AGENDA
ST. TAMMANY PARISH PLANNING COMMISSION MEETING
6:00 PM – MONDAY, MARCH 18, 2024
ST. TAMMANY PARISH GOVERNMENT COMPLEX
PARISH COUNCIL CHAMBERS
21490 KOOP DRIVE, MANDEVILLE, LOUISIANA

PLANNING STAFF REPORT
2024-3718-MSP

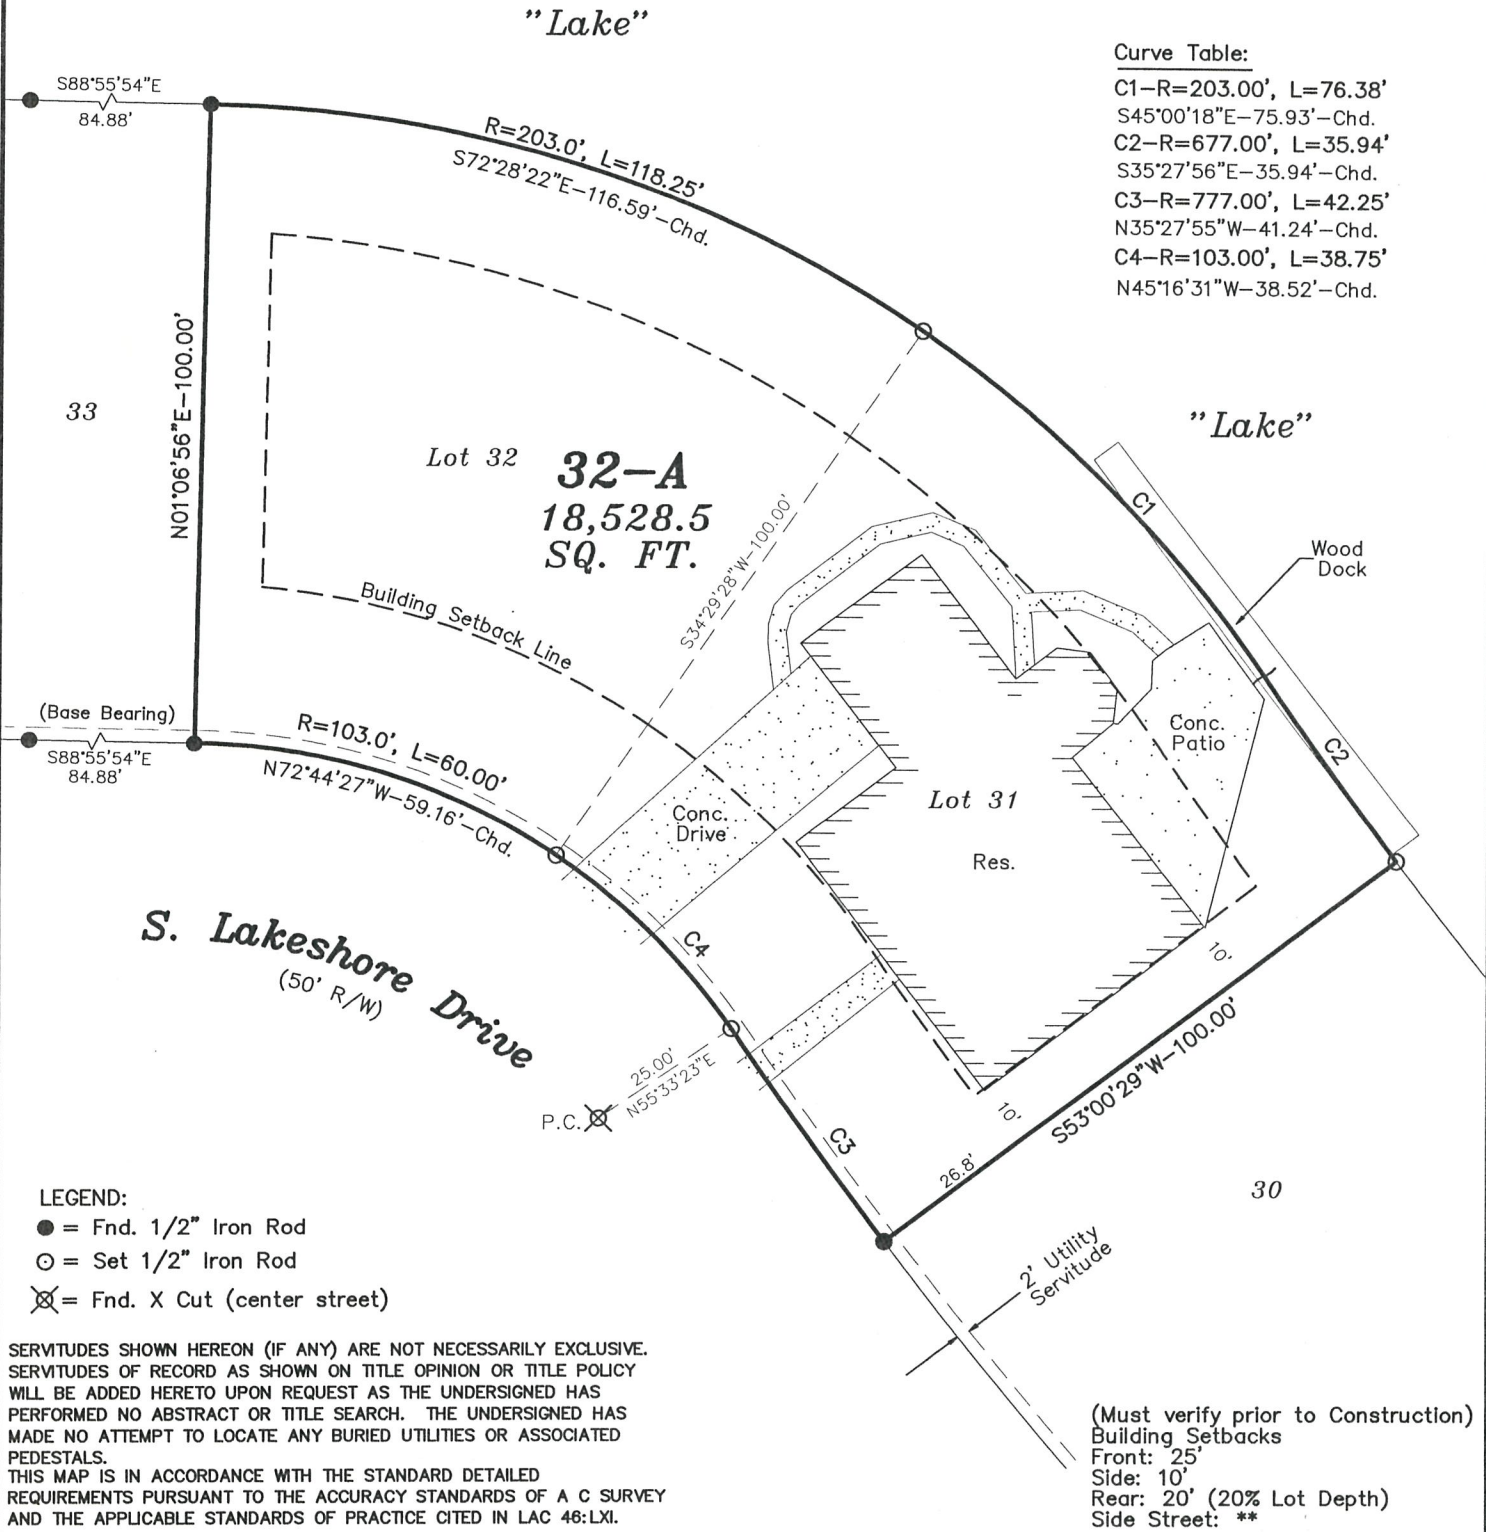
1. Add signature line for the Chairman of the Planning Commission.
